1137 Ogilvie Road and 1111 Cummings Avenue

**RE: UDRP Report
PC2024-0171
1137 Ogilvie Road and 1111 Cummings Avenue – Zoning By-law Amendment**

1137 Ogilvie Rd Architectural Design Report for Application for Rezoning 2024.07.18

PODIUM ARTICULATION Plan concept and sketch overlay

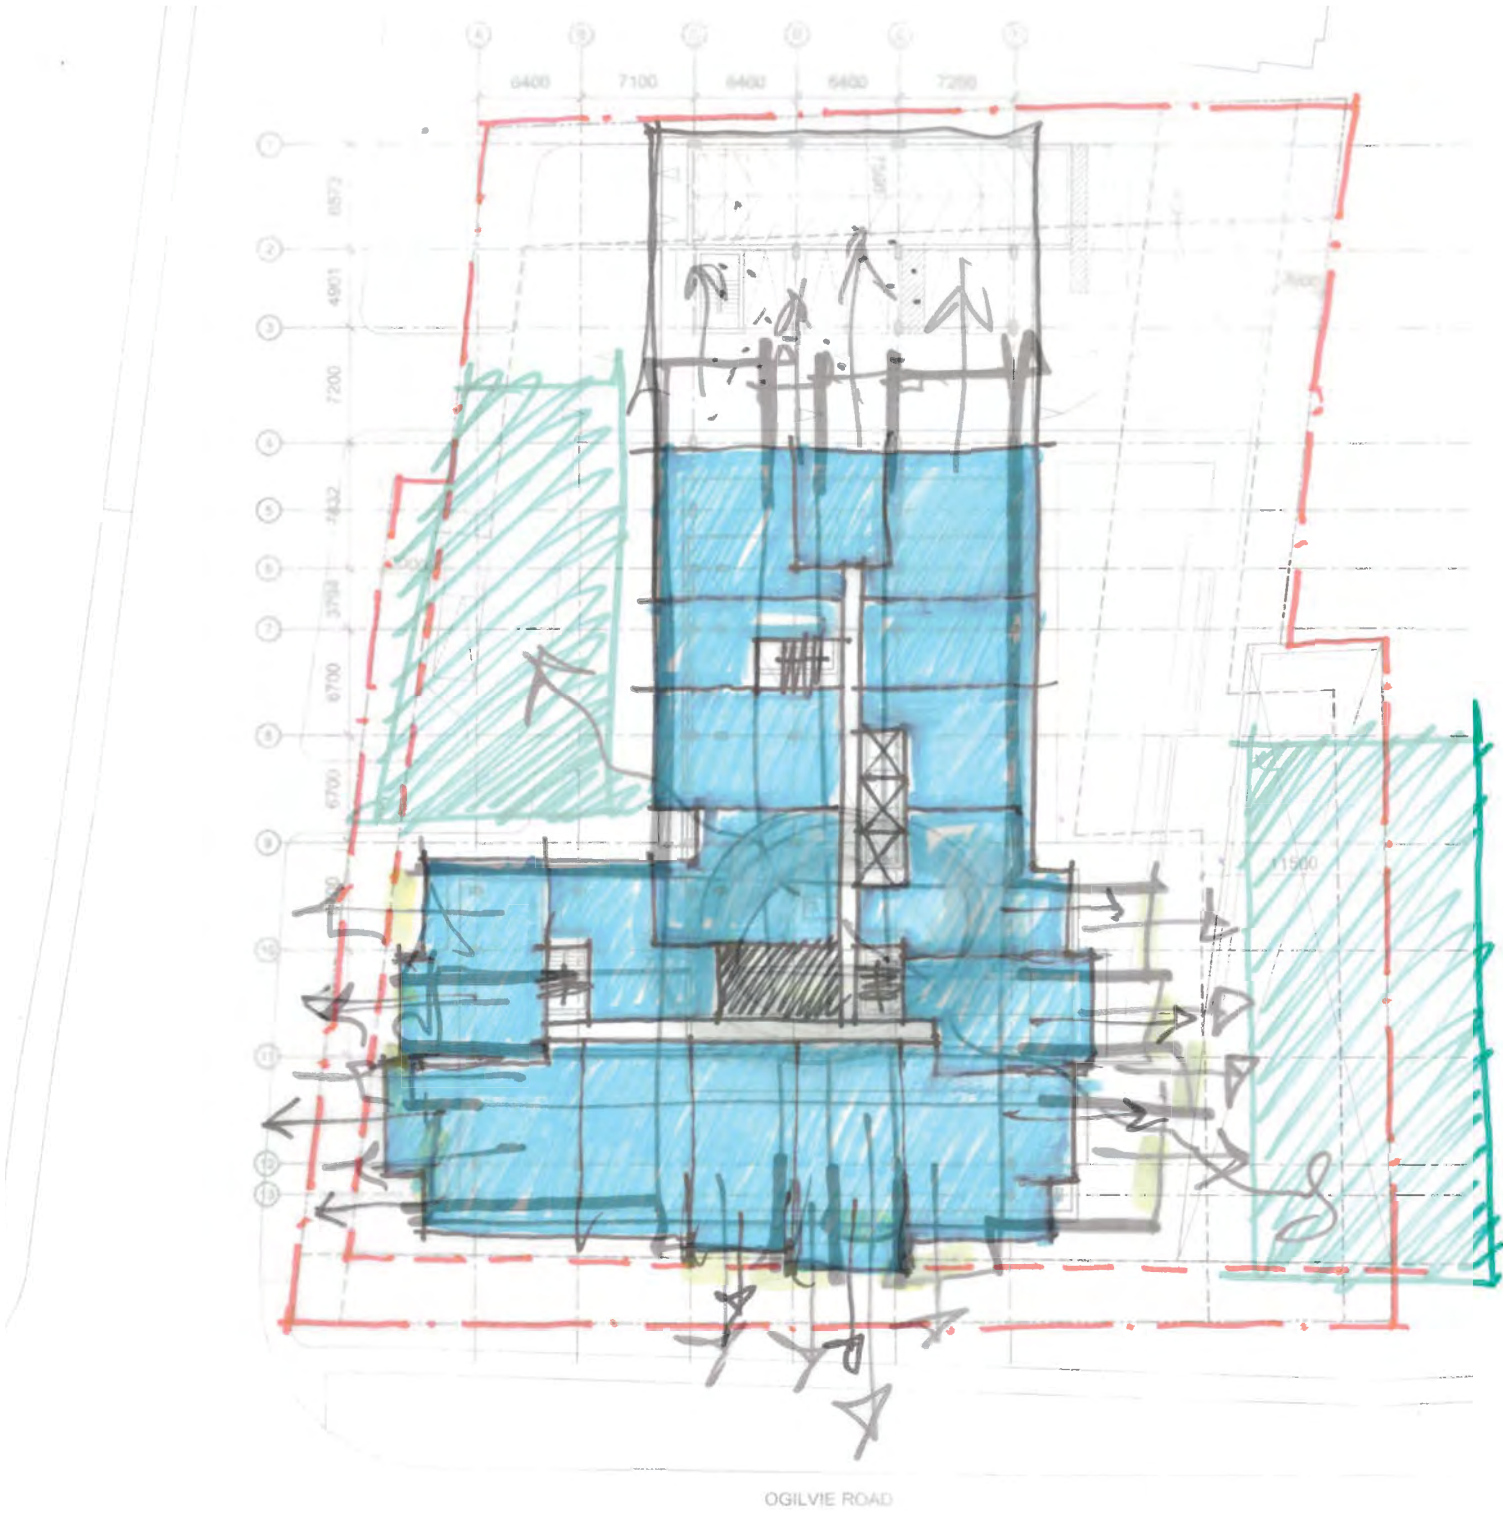
20	The Panel supports and appreciates the vision and concept showcased on p.11 of the submission ('warp and weft'), but has concerns that the transparency, porosity, and connectivity imagined in the hand sketches are not fully taking shape in the ground floor plans. Explore ways to bolster that imagined connectivity and porosity in the ground floor plan.	The landscape consultant site concept has demonstrated a further enhancement of the overall site plan strategy, and Figur3 has been retained as the interior design consultant. Together, the architectural, interiors and landscape consultants will ensure that the concepts of connectivity, porosity and integration are carried through to the site plan approval, final design and construction phases.
21	The Panel recommends exploring ways to connect the site to the greater surrounding landscape network.	Noted. Please refer to the landscape consultant site concepts that address these items.
